SERVICE TECHNICAL INFORMATION

ONE POINT REPAIR

REF. NO. : SI-96-013

MODEL : CSD-ES50 / ES60 / ES70 / CA-DW700M / NSX-E7M
SUBJECT : Remote control does not operate
SYMPTOM : The height of the positive terminal (+) with some AA batteries is low. When such batteries are used, the battery does not make contact with the positive terminals (+) of the remote control unit and so the unit does not operate.

Remote Control (bottom)

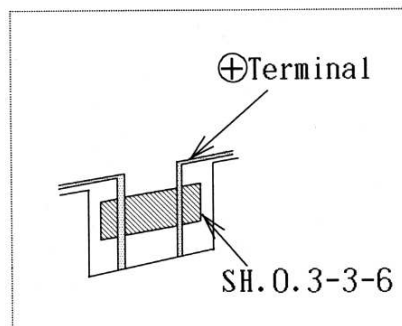
(Battery with which this condition has been currently discovered: Duracell)

REMEDY : Attach a spacer to the positive terminals (arrow) of the remote control unit (refer to the figure below).

Use tweezer to attach to the back of the positive terminal.

Part No.	Part Name	Ref. No.
SV-T00-024-010	SH, 0.3-3-6	—
